W7100A Errata Sheet

Document History

Ver. 1.0.0 (Feb. 23, 2012)	First release (erratum 1, 2)
Ver. 1.1.0 (Sep. 10, 2012)	Added the erratum 3

Erratum 1

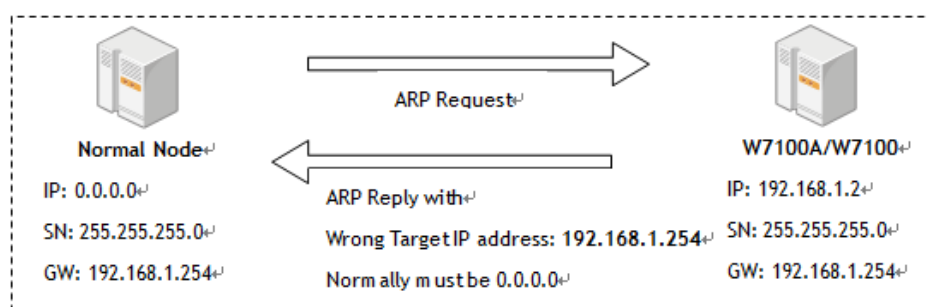
The W7100A replies with gateway IP address for the ARP request from network node which has "0.0.0.0" IP address. But normally the W7100A should replies with target IP address "0.0.0.0" not the gateway IP address.

The main reason of this erratum is subnet calculating logic. The W7100A misunderstands the node locates other sub-network when target has "0.0.0.0" IP address. So the W7100A set the target IP to the gateway IP instead of "0.0.0.0" and sends the ARP reply.

The "0.0.0.0" is abnormal IP address in common network so if any node has "0.0.0.0" in the network, stop its ARP processing until getting the valid IP address.

Erratum 2

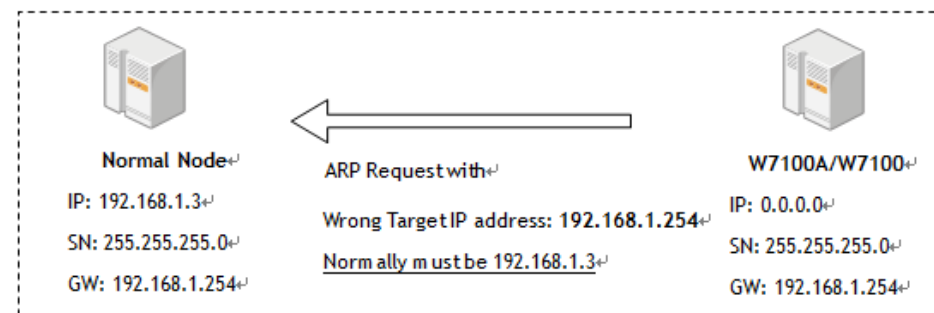
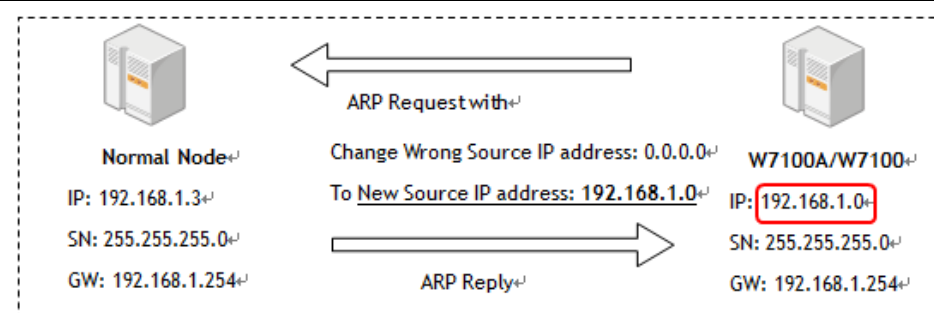
Assuming that the IP address of W7100A is “0.0.0.0” and the gateway, subnet mask is valid (not “0.0.0.0”), the W7100A set the target IP address of ARP request to the gateway IP address not the target node IP address when sends ARP request to another node. So the peer node cannot receive the ARP request from the W7100A.

The W7100A miss calculates the sub-network location when sends the ARP request if its own IP address is “0.0.0.0”. In the same condition, even if the gateway IP address is “0.0.0.0”, the W7100A sends ARP request to “0.0.0.0” IP address because the W7100A sends ARP request to the gateway.

Do not set the IP address of W7100A to “0.0.0.0” to avoid this problem. If don’t have valid IP address but want to send ARP request, please set the temporal IP address referring the gateway IP address and subnet mask. Normally common nodes cannot set zero IP address as its own IP address. So use this IP as a temporal IP address. For example, assuming that the gateway IP address is 192.168.1.1 and the subnet mask is 255.255.255.0, a temporal IP could be “192.168.1.0” or any unused IP could be the temporal IP address for the W7100A.

Erratum 3

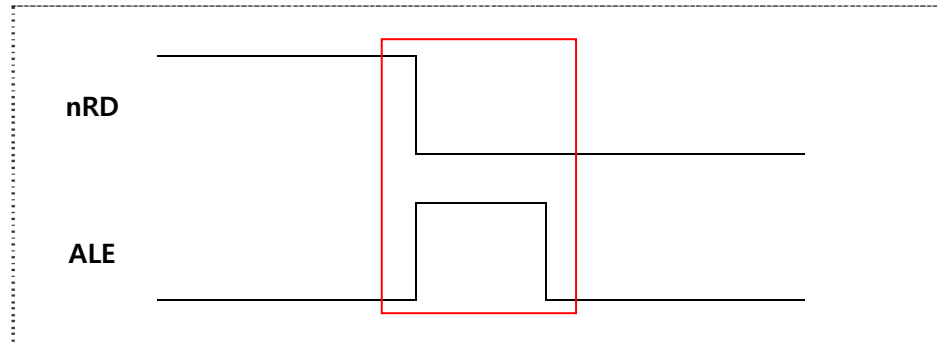
W7100A uses the ALE (address latch enable) signal when controlling the external memory with Standard 8051 interface. An erratum of the ALE signal turning on after the nWR / nRD signal is enabled can occur; and can cause a bus collision or abnormal external memory access.

When the external memory is controlled using Standard 8051 interface.

To resolve this erratum, OR the nWR / nRD signal with ALE signal and connect it to the external memory. Then the nWR / nRD signal will occur after the ALE signal and the external memory can be controlled normally.
